ATTACHMENT I

PROPOSED TECHNICAL SPECIFICATION CHANGES

CONSOLIDATED EDISON COMPANY OF NEW YORK, INC.
INDIAN POINT UNIT NO. 2
DOCKET NO. 50-247
OCTOBER, 1996

ATTACHMENT II
SAFETY ASSESSMENT

FIGURE 3.1.A-1
PORV OPENING PRESSURE FOR OPERATION LESS THAN OR EQUAL TO 305°F

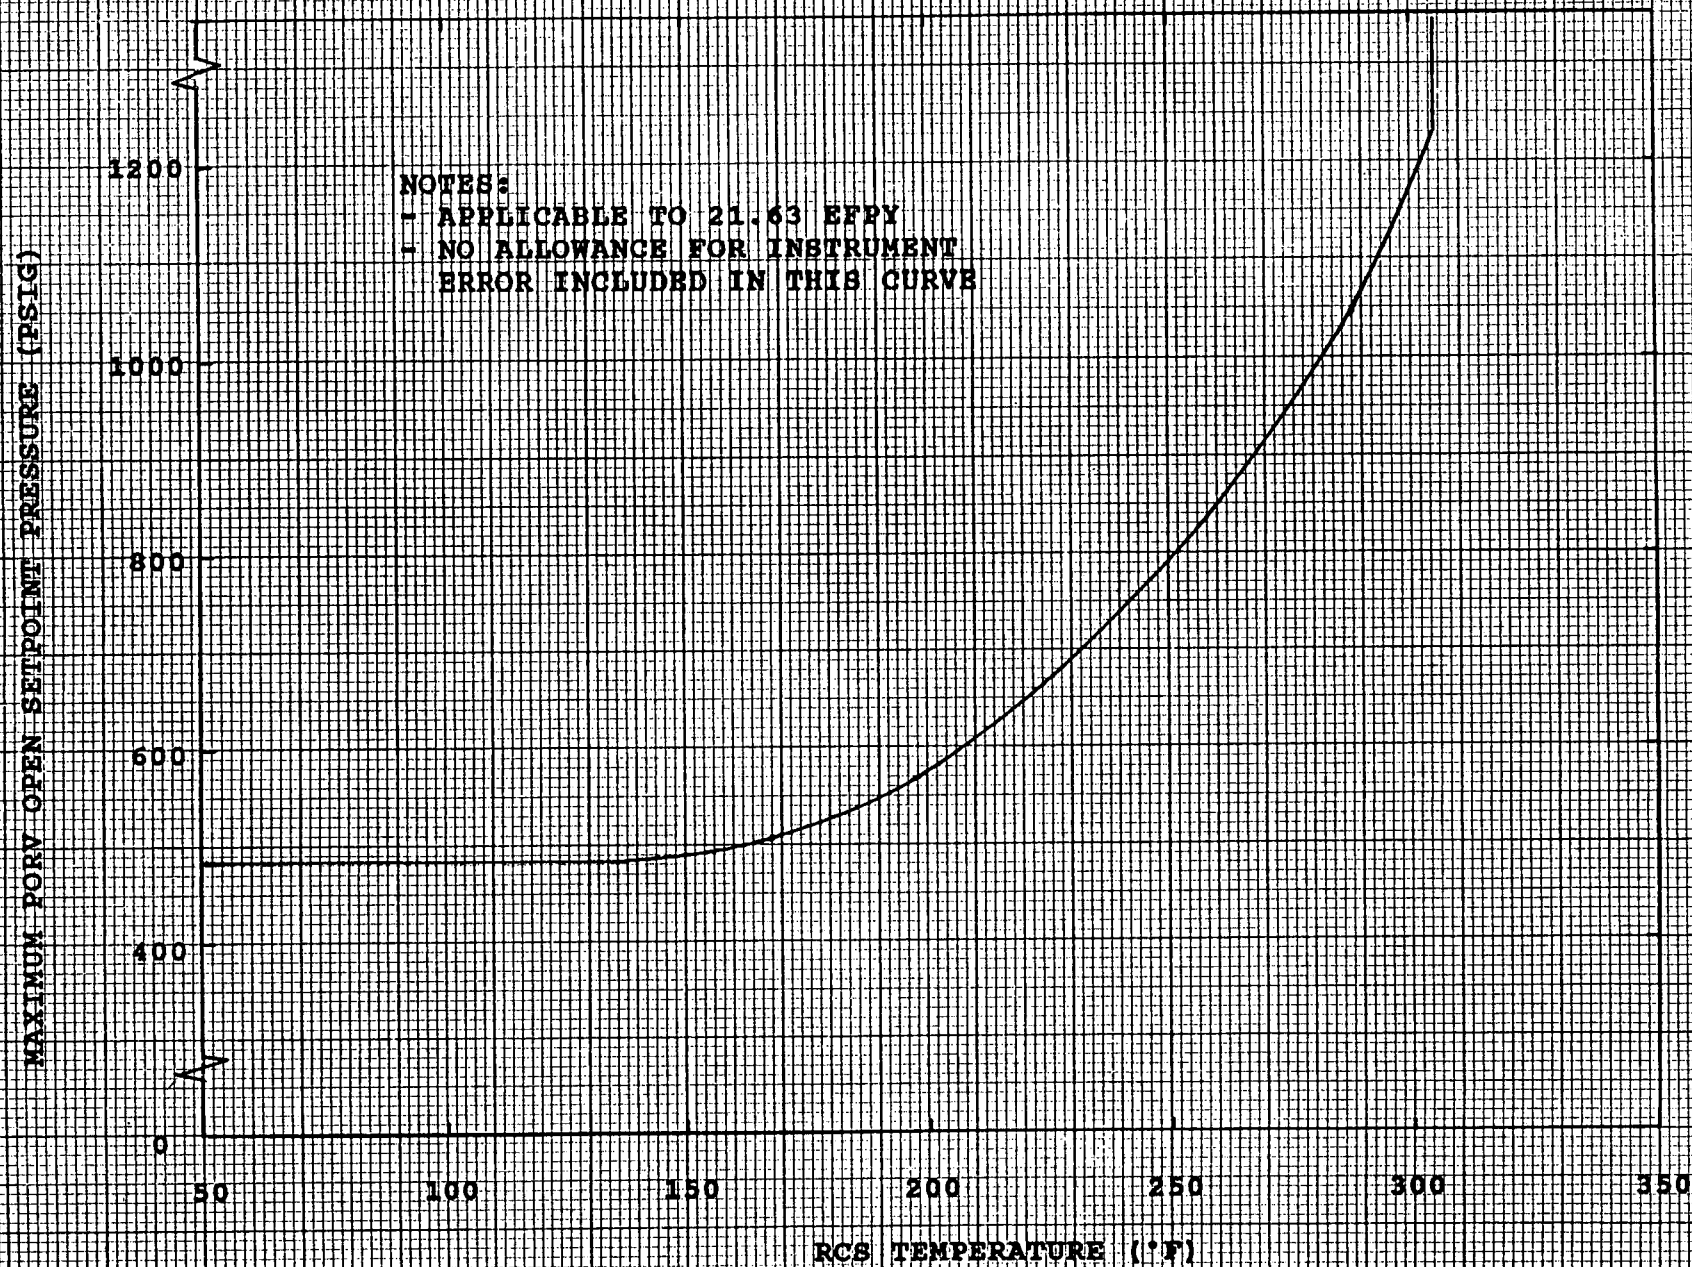
This application for amendment to the Indian Point 2 Technical Specifications seeks to amend Figures 3.1.A-1, 3.1.A-2, and 3.1.A-3, Section 3.1.B and its bases, Figures 3.1.B-1 and 3.1.B-2 and the bases of Section 4.3 and Figure 4.3-1.

We have compared the Indian Point 2 21.63 EFPY heatup/cooldown curves versus those calculated using the method adopted by the Code Committees and they are within 2% of each other. The differences cannot be discerned from the plotted curves. Therefore we request the removal of the limiting conditions as noted by asterisks in our current specifications. In addition, for clarification, the graphs have been extended to lower temperatures. Table of values will be provided to the operators.
